Ecology – Proof of Evidence Summary

Planning Appeal by Exagen Development Ltd Against the Refusal of a Full Planning Application for the construction, operation and subsequent decommissioning of a renewable energy park comprising ground mounted Solar PV with co located battery energy storage system (BESS) at the point of connection, together with associated infrastructure, access, landscaping and cabling

Land West of Bradmore Road and North of Wysall Road,
Land West of Wysall, Wysall
Known as: Old Wood Energy Park

Planning Application Reference: 24/00161/FUL

Figure 1 Skylark Mitigation Suitability Plan Showing areas following above guidance/research.

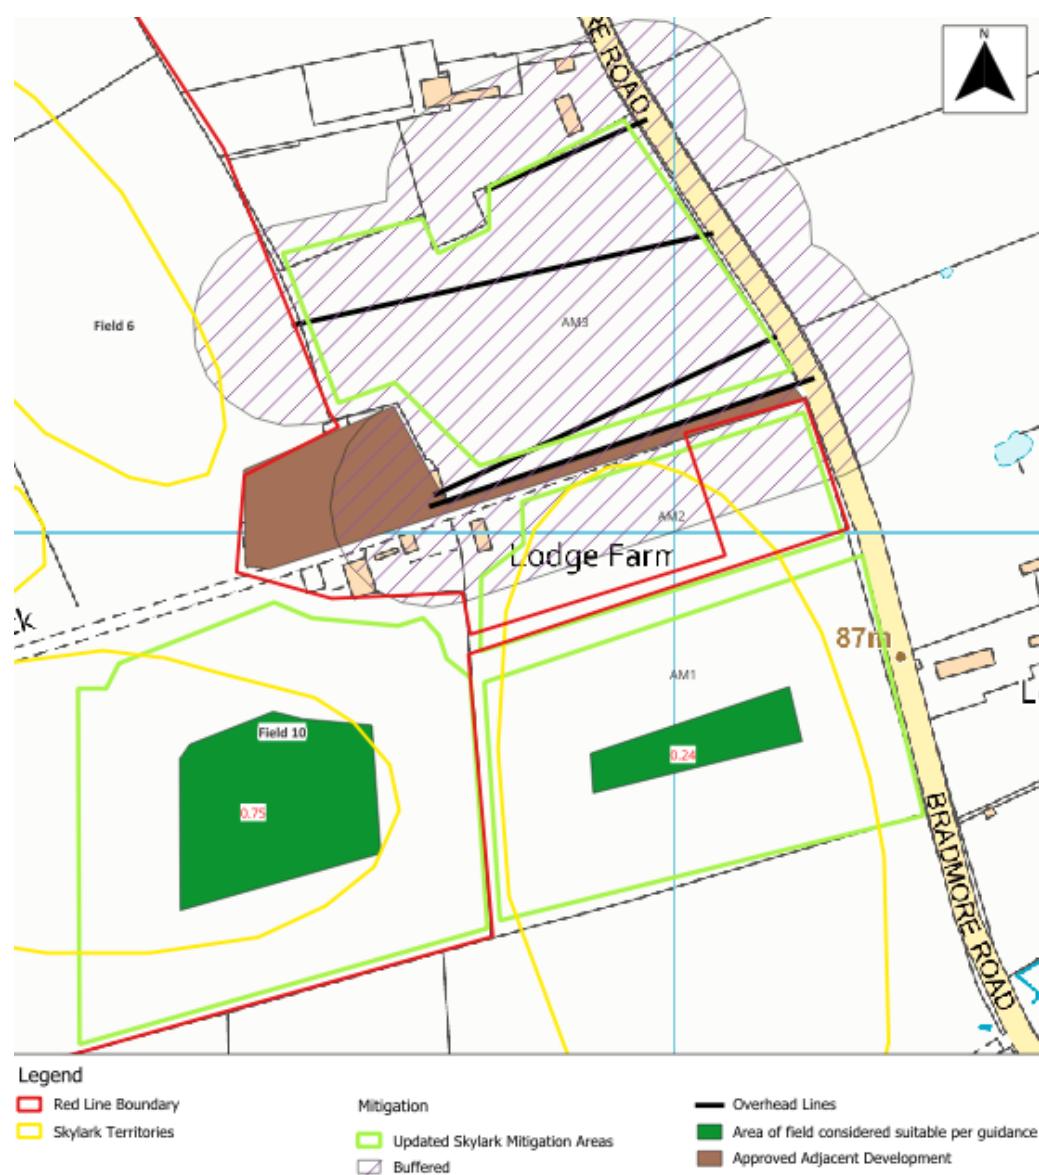
3.1.2 The Appellant's Main SoC Ecology Appendix relies heavily on a prototype that has, as yet, not become best practice nor has it become a widely used or accepted mitigation method. It also fails to apply well researched and evidence-based data including Government and RSPB guidance (CD 10.5, CD 10.9 & CD 10.10) on creating suitable habitat for nesting skylark taking into account nesting preferences and predation risks, including:

- Fields with open, unobstructed aspects (CD 10.4, 10.5, 10.6, 10.9 & 10.10);
- Limited/no boundary vegetation (Wilson et al. 1997 – CD 10.12 Summary paragraph 2 Pg. 1462);
- Hunnick et al, 2025 showed that “*increasing proximity of tall structures such as buildings, trees and electricity poles strongly reduced Skylark habitat occurrence... forests and single trees are strongly avoided up to around 100 m*” (Pg. 303 CD 10.13); and
- Mitigation should be located away from field boundaries/ tall structures, “*Candidate receptor fields should feature low (<2m high) boundary features, no buildings*” (H.Fox, 2022 CD 10.1).

Original AB4 Gov guidance (CD 10.9 in the 'Where to use this option' and 'Where this option cannot be used' sections)	Updated AHW4 guidance (CD 10.10 in the 'Where you can do this' and 'Choosing the right location' sections)
Fields must be >5 hectares with an open aspect (or at least 10ha where fields are bounded by tall vegetation/woodland)	Fields should be >5 hectares with an open aspect (or at least 10ha where fields are bounded by tall vegetation/woodland)
>50m from field boundaries and margins	>80m from field edges, telegraph poles, pylons.

Issues with the original mitigation (one field split with the eastern part c. 3.62ha as mitigation)	Relevant guidance/research	Any changes to the issues raised when considered against the updated mitigation (Fields outside red line boundary and part of Field 7.)
<5ha field & no open aspect	Fails to meet government, RSPB & CFE advice (CD 10.5, CD 10.6, CD 10.9 & CD 10.10)	None, each field is still <5ha and no open aspect
Enclosed by >2m tall vegetation/buildings/pylons	Fails against all relevant and widely accepted guidance and research as well as not meeting the preferred boundaries as per H.Fox, 2022 - see paragraph 3.4.2 bullet 5 above. (10.4, CD 10.5, CD 10.6, CD 10.7, CD 10.8, CD 10.9, CD 10.10 and CD 10.12).	Additional field AM3 has further suitability restrictions due to presence of multiple overhead wires (increased predation risk).
Post landscaping and construction the field becomes further enclosed by security fencing and landscaping including trees.	As per above	As per above.
